Tapu & Noa:

Interpretation

Interpreting Ngā Paerewa Hoahoa
Whare: Table 2.1-2 Tapu & Noa Planning
Matrix

17/08/2023

One Storey - Analysis

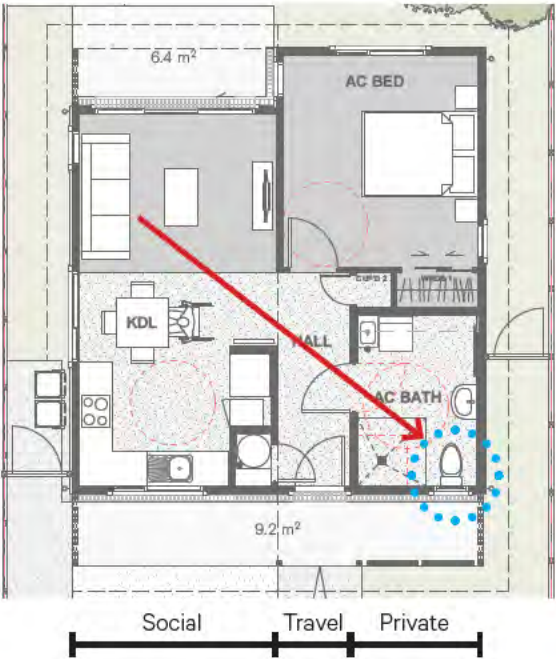
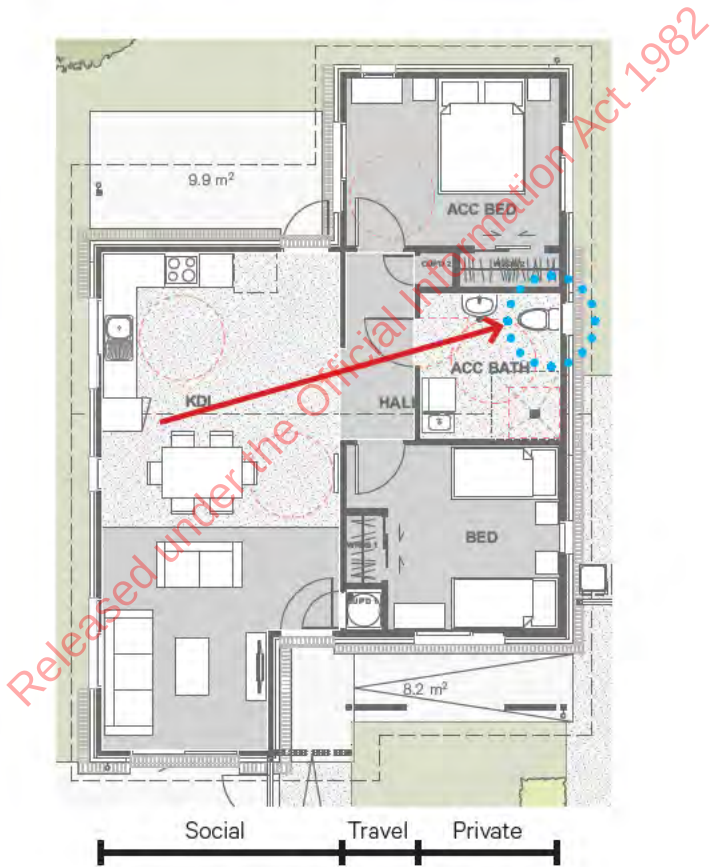
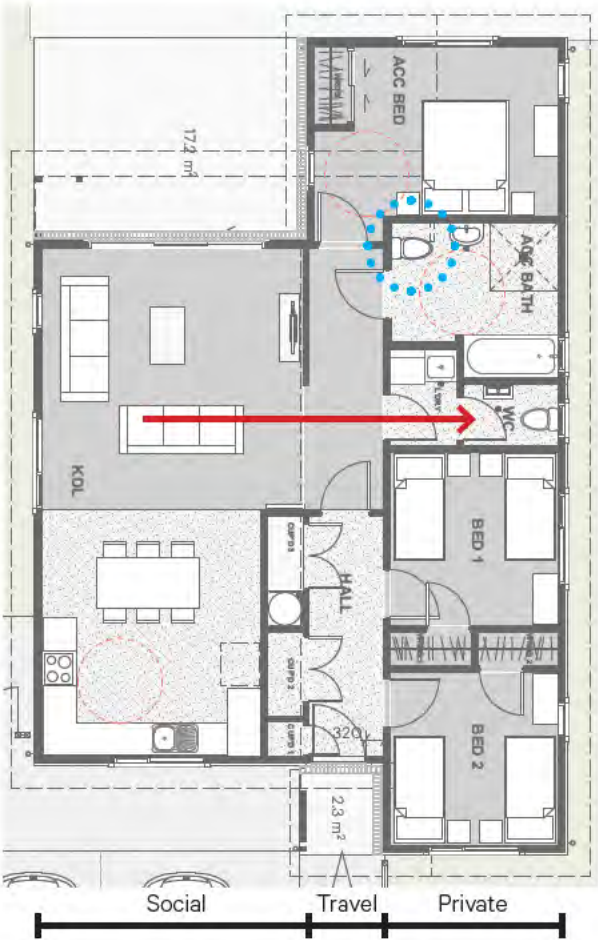
→ Sightlines

○ Combined WC

Two Storey - Analysis

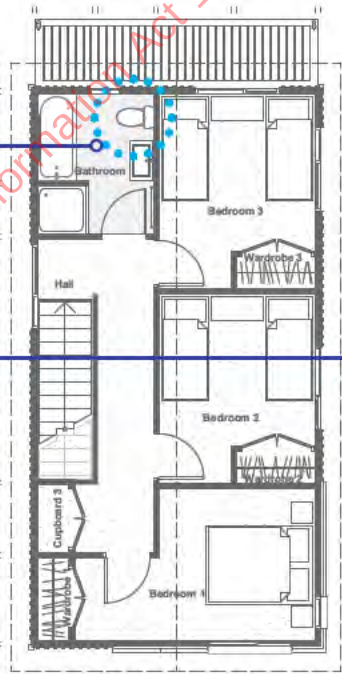
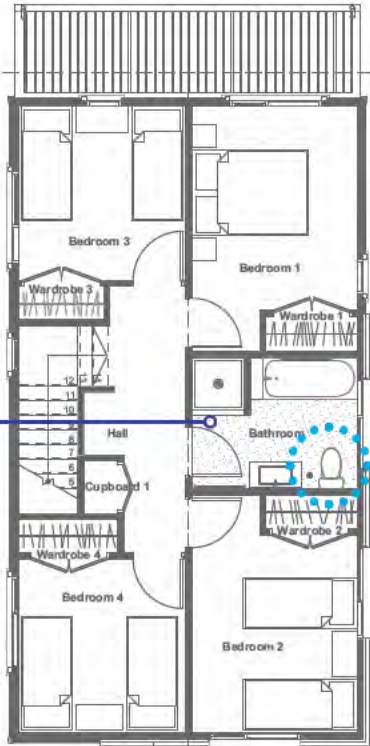
- Sightlines
- Combined WC
- - - Toilets Above

Acquisitions / OSM / WIP - 2 Bedroom - **Analysis**

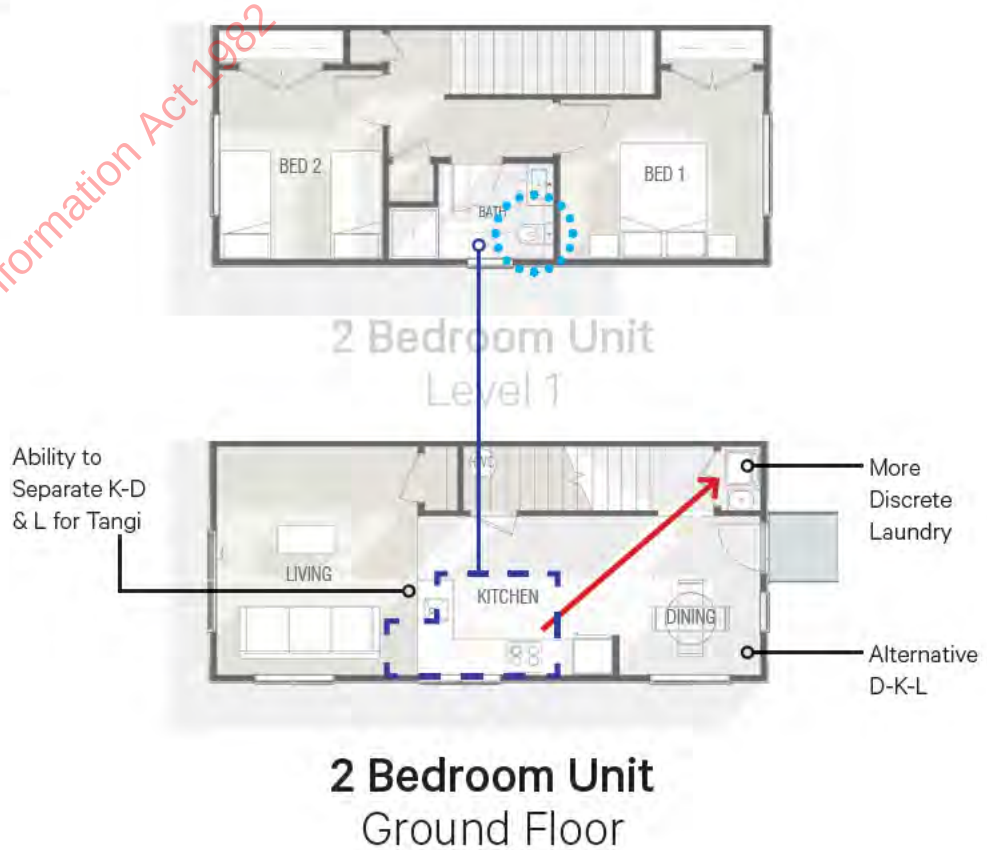
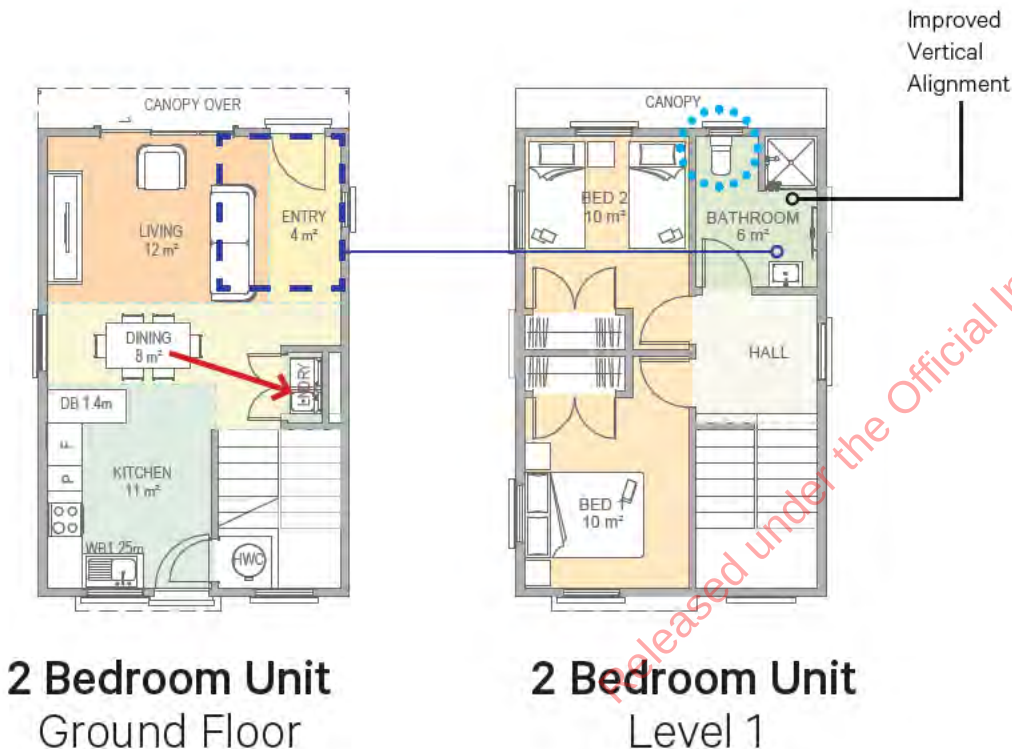
- Sightlines
- Combined WC
- - - Toilets Above

Acquisitions / OSM / WIP - 3 Bedroom - **Analysis**

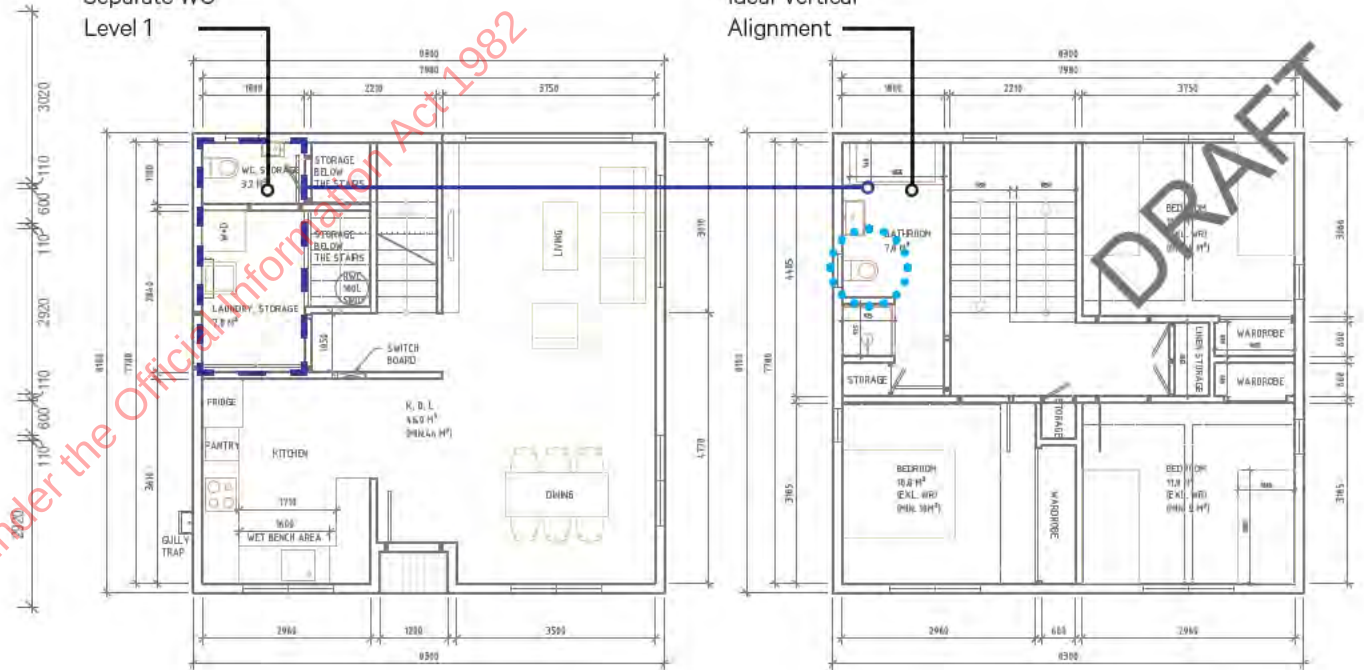
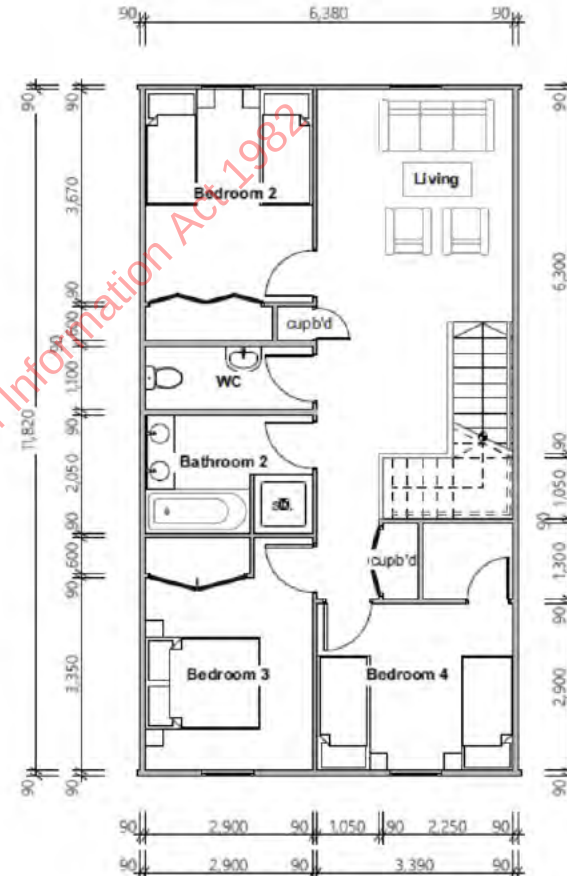
Separate WC
Level 1

- Sightlines
- Combined WC
- Toilets Above
